RE: **Bruno Residence**
8001 Fuji Court
Revised Grading Plan
Engineer's Stamp Date 1/15/18 (File: E10D029)

Based on the information provided in your submittal received 1/17/18, the Grading Plan is re-approved for Building Permit.

RE: **Bruno Residence**
8001 Fuji Court
Grading Plan
Engineer's Stamp Date 2/1/17 (File: E10D029)

ENGINEER'S SEAL 1/15/18 DAVID SOULE P.E. #14522	8001 FIJI COURT BRUNO RESIDENCE	DRAWN BY WCVJ DATE 1-11-18
	GRADING AND DRAINAGE PLAN	21701-LAYOUT-1-10-17
 Rio Grande Engineering 1606 CENTRAL AVENUE SE SUITE 201 ALBUQUERQUE, NM 87106 (505) 872-0998		SHEET # — JOB # 21701

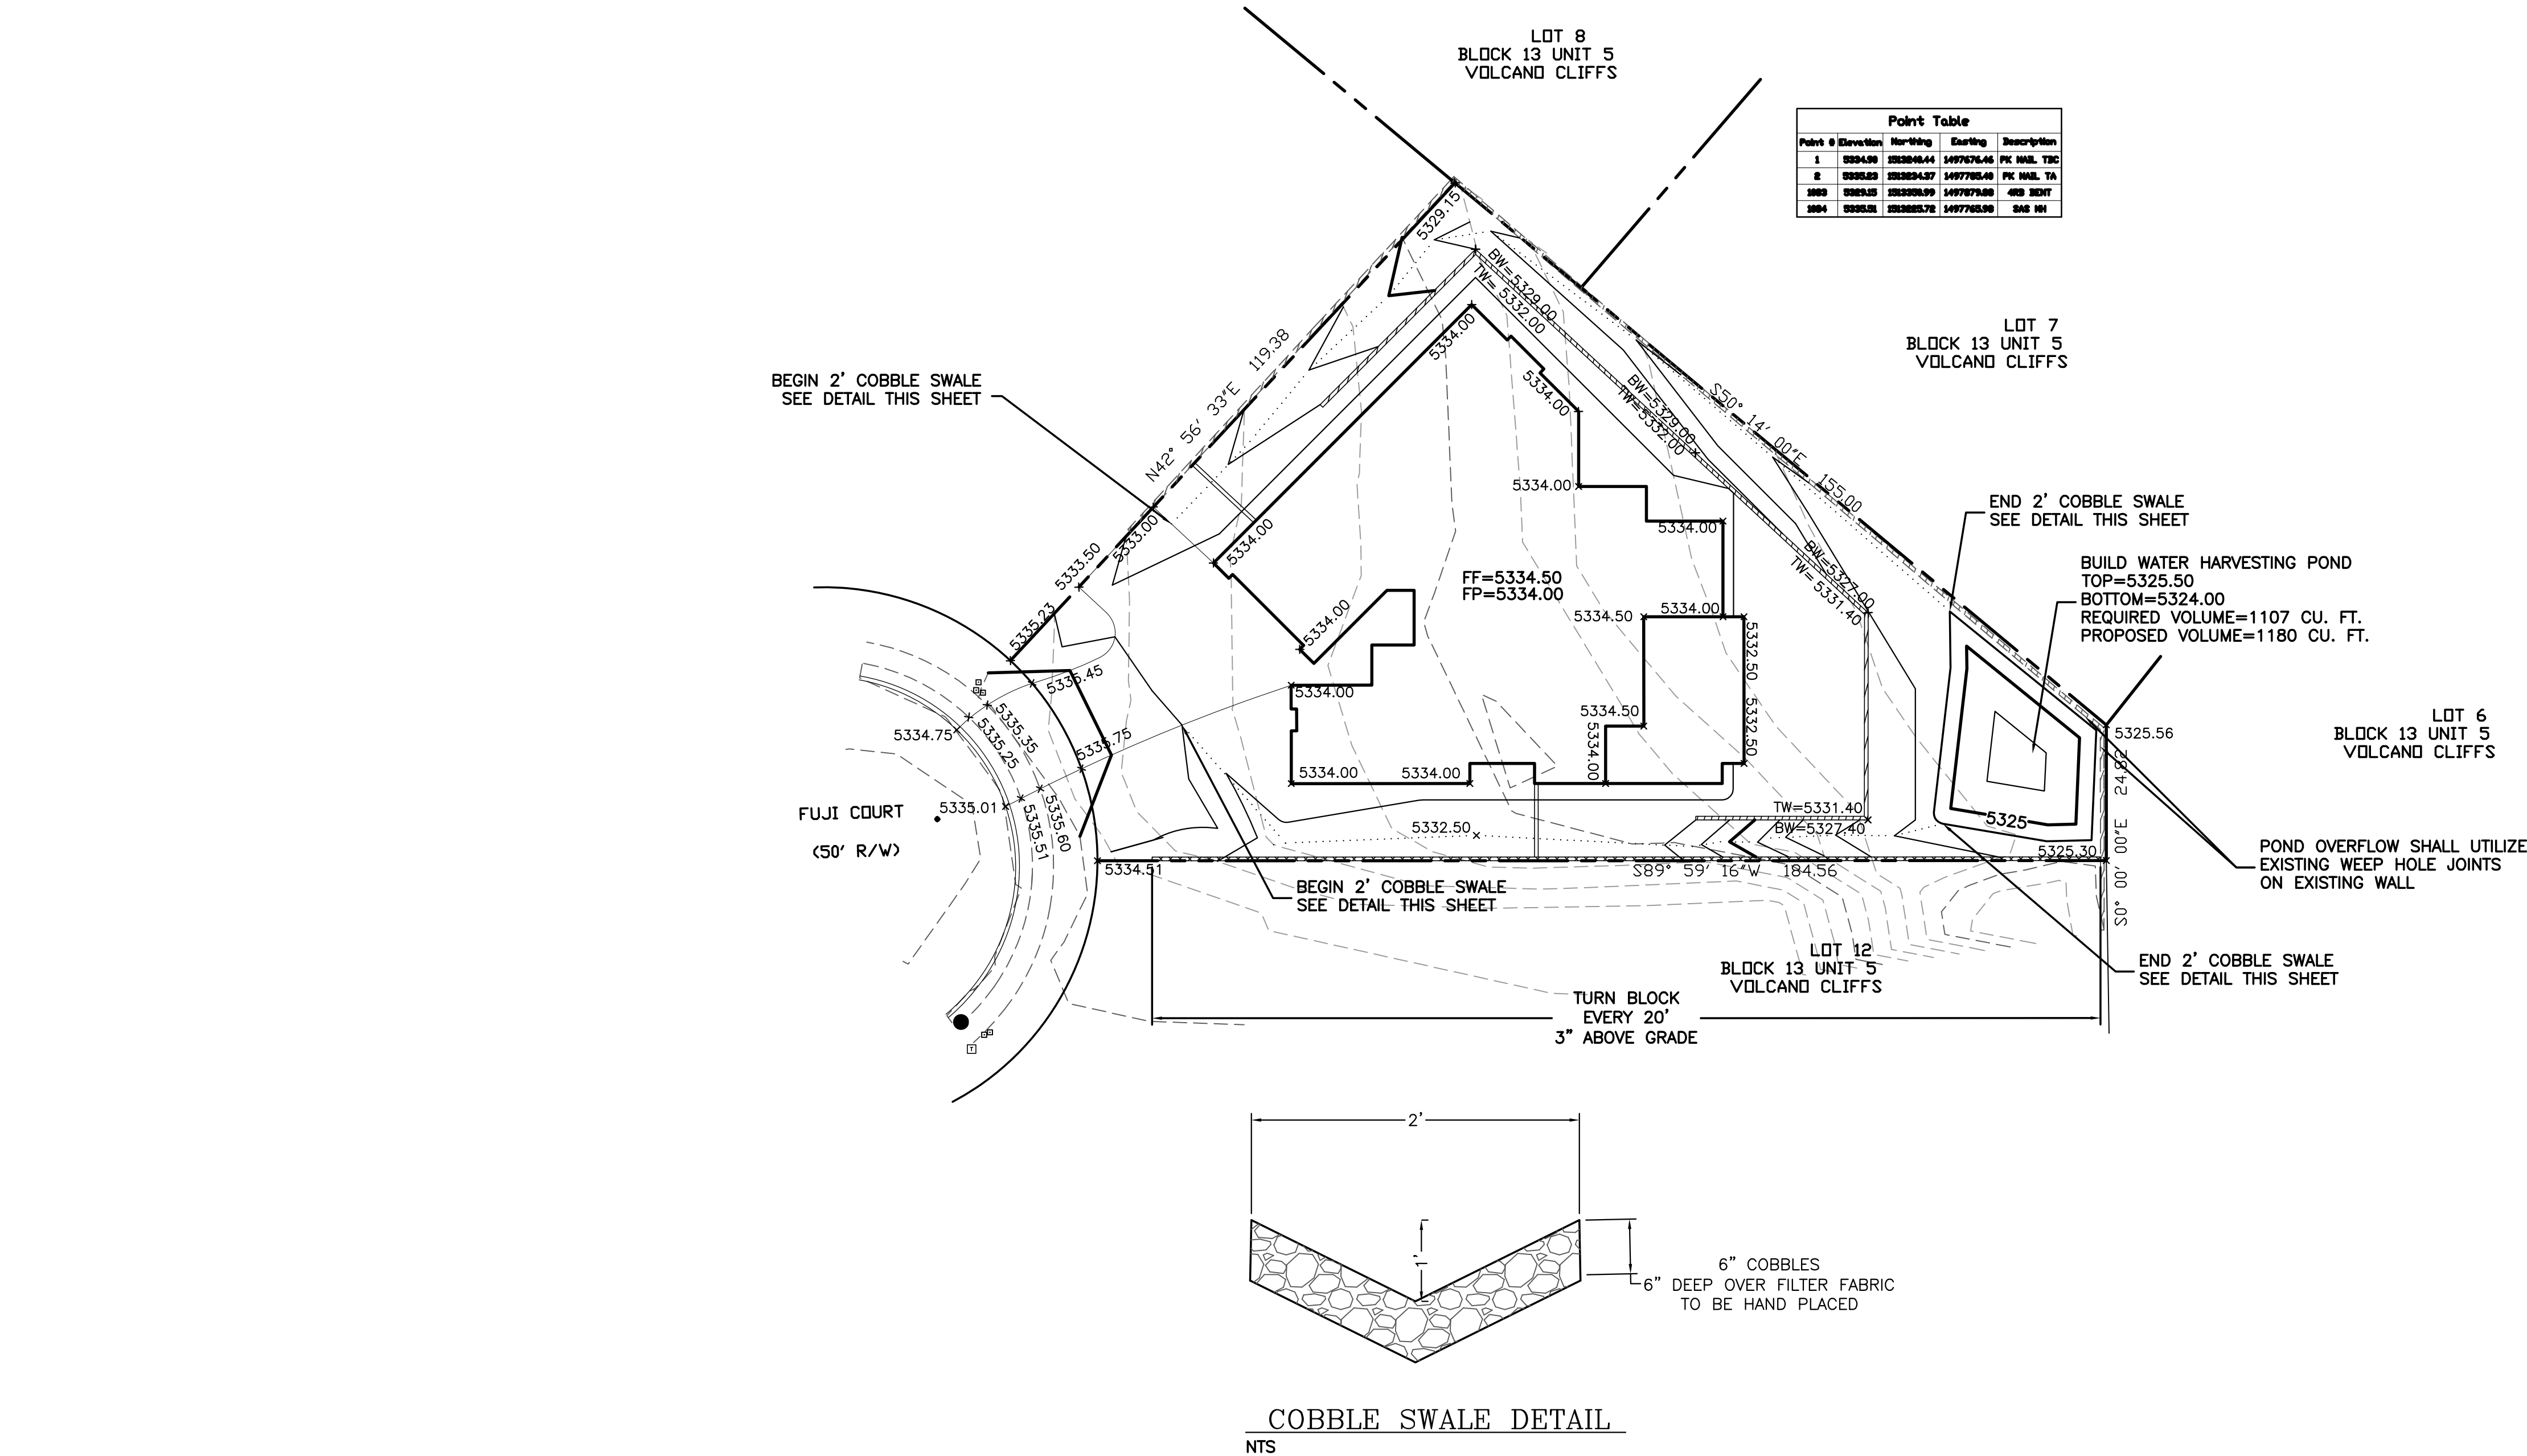
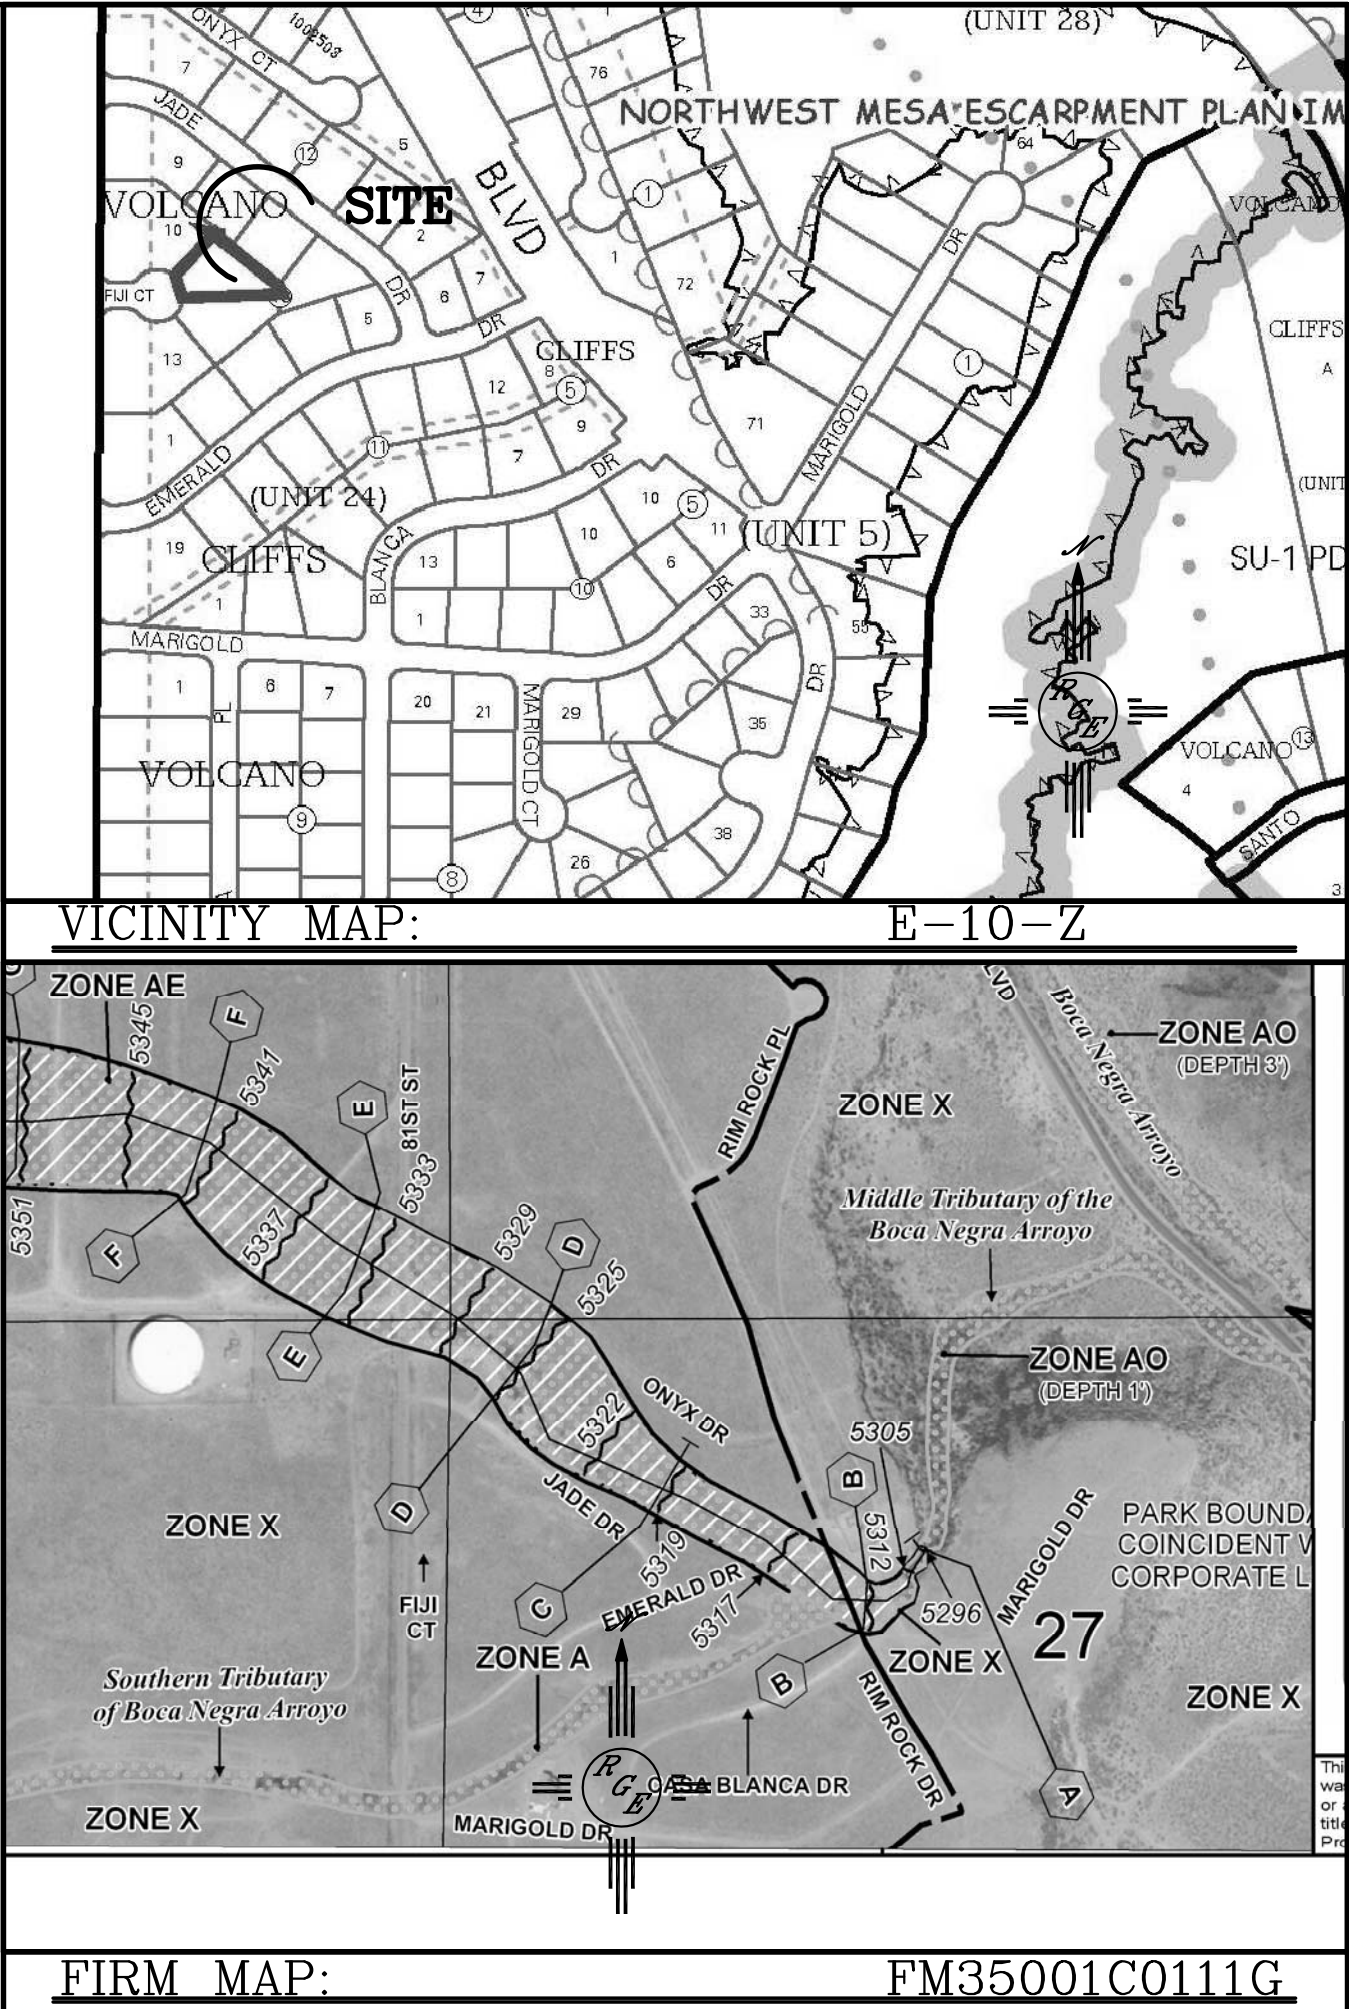
*** revised plan to eliminate retaining wall integral with house, utilized retaining wall within yard
